# **I-81 VIADUCT PROJECT – PHASE 1, CONTRACT 2**

**PIN 3501.91, Contract D900056**

**Addendum #1**

**December 6, 2022**

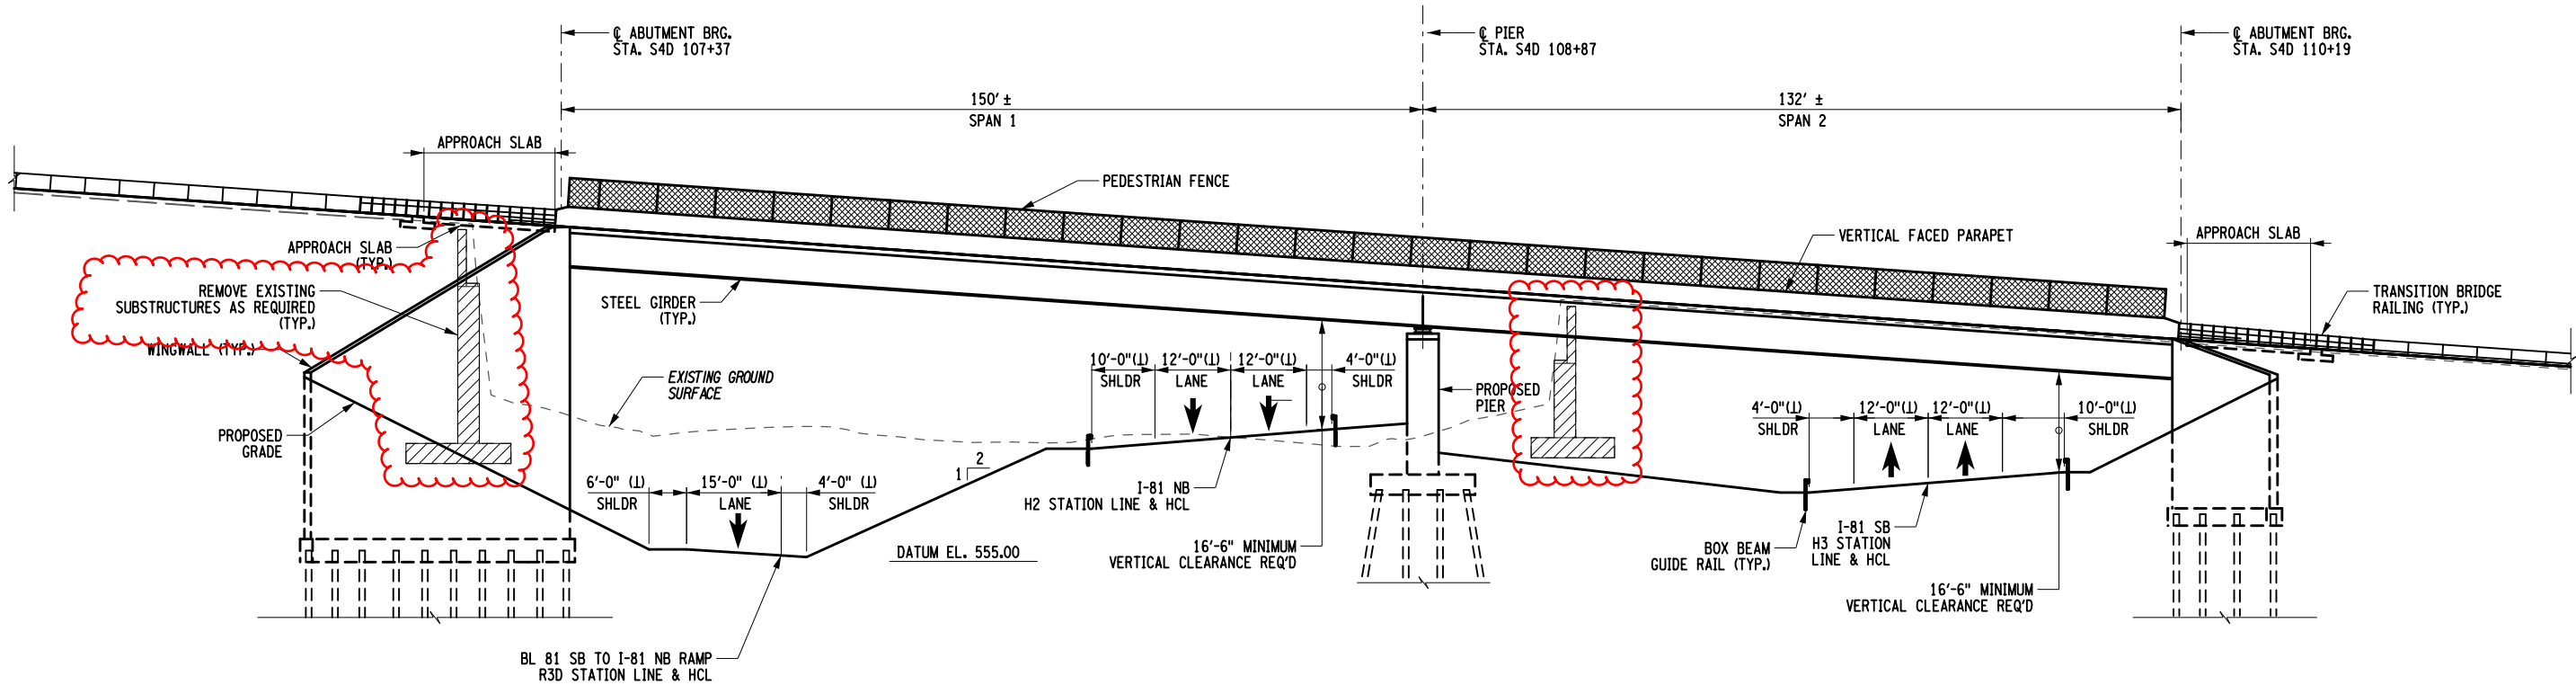
Revisions made:  
Existing substructures added to Elevation View  
and hatched to be removed, as required.

**Southern Interchange Boundary Map**

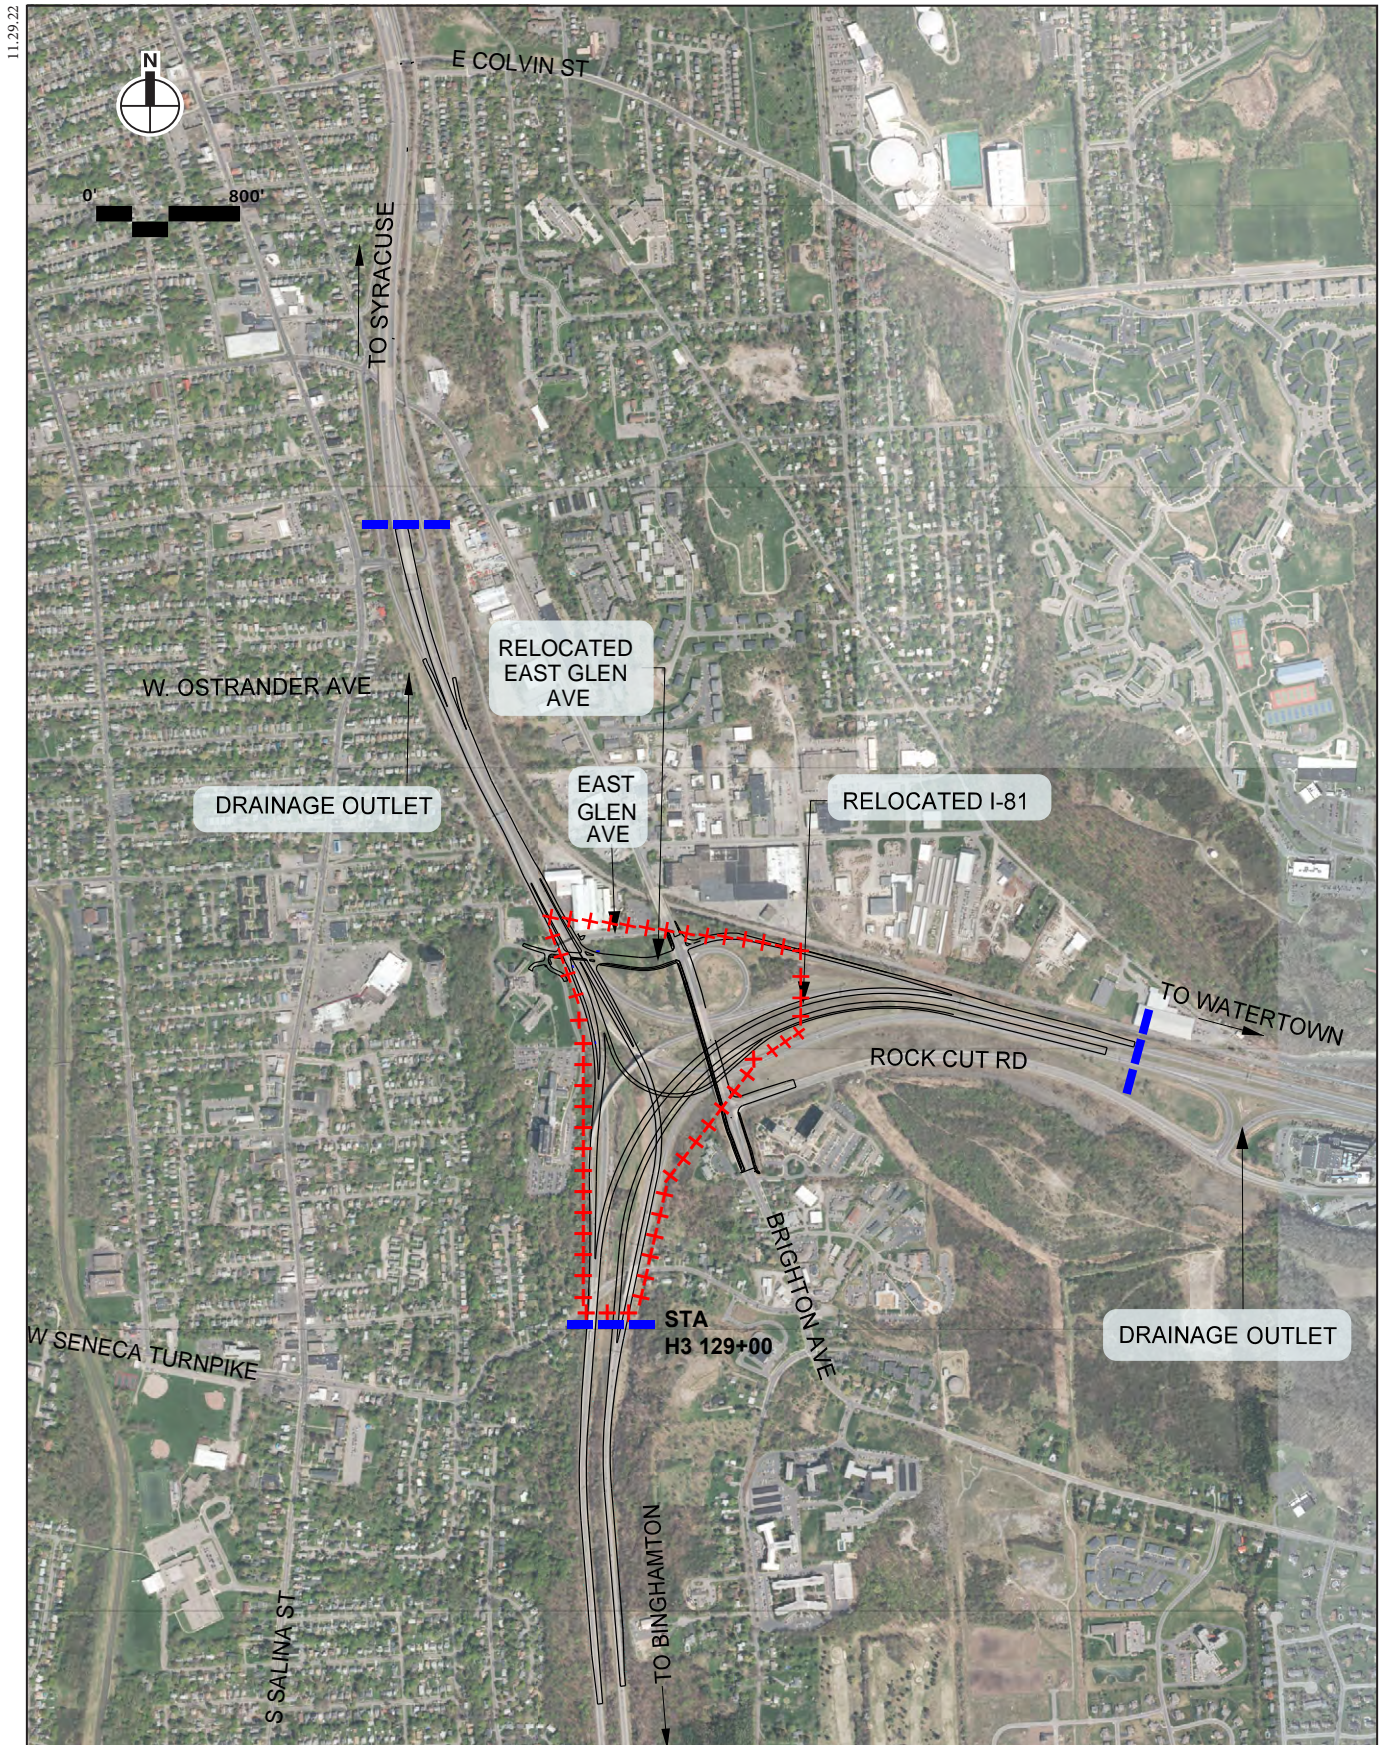
Add the attached Structural Details – Fixed Frame Abutment drawing, Page x, and the Southern Interchange Impervious Drainage Limits & Potential Existing Sinkhole Area of Concern Map to the DB Contract Documents, Part 7, Engineering Data (Part 5 of 5).
